LiDAR Quality Assessment Report

Materials Received: 2/22/2013	Project Type: Donated Data
Project ID:	Project Description:
OR_OLCTillamookYamhill_2012	
Project Alias(es):	Year of Collection: 2012
Tillamook-Yamhill	
1	
Lot 1 of 1 lots.

OR_OLCTillamookYamhill_2012

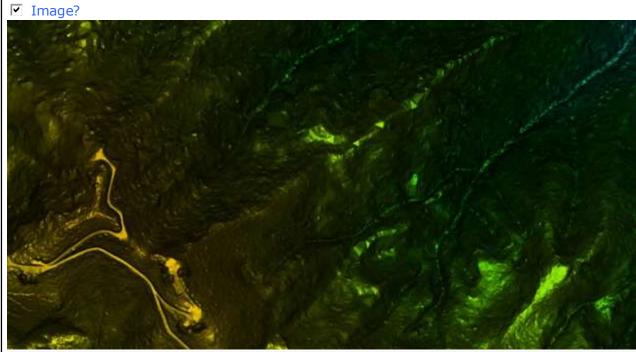
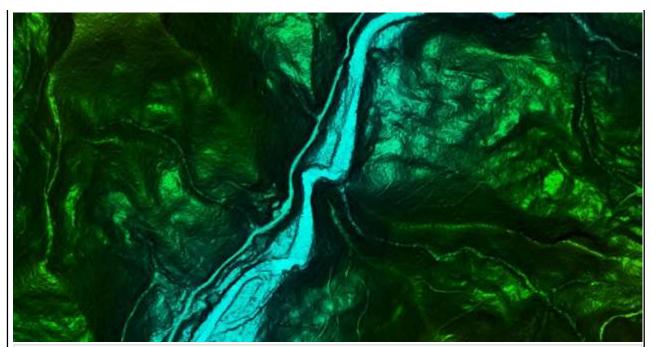
□ Image?	
Tiles Overlap, no edge artifacts observed, Final to NED Mosaic not impacted.

Large portions of the DEM exhibit a Tinny character due to the heavy amount of forest throughout the dataset and fewer returns penetrating the canopy, this is to be expected.

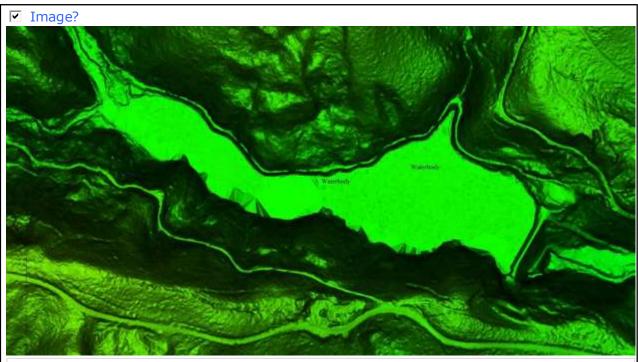
Many cases of streams with a wide equal to or greater than 100ft, these streams are not flattened in a downstream monotonic manner and are the primary reasons the dataset is NOT recommended for the 1/3rd NED.

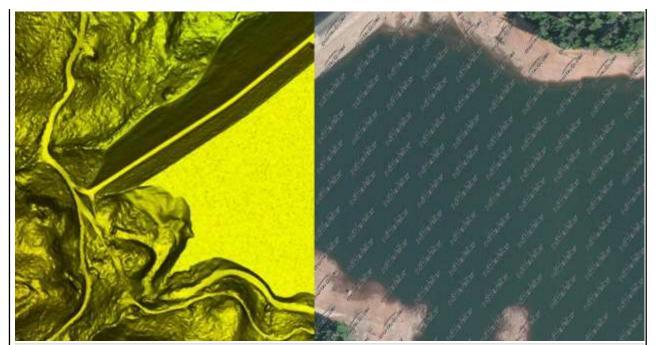
A few Instances of Waterbodies in excess of 2 Acers which are not hydro flattened. As there are only a few occurrences of this issue, USGS choose to flatten them for the Final to NED product.

There were two instances of much larger waterbodies which appeared to have very dry or empty conditions, these are not leveled and will not be leveled for the NED as the reflect bare earth at the time of collection.
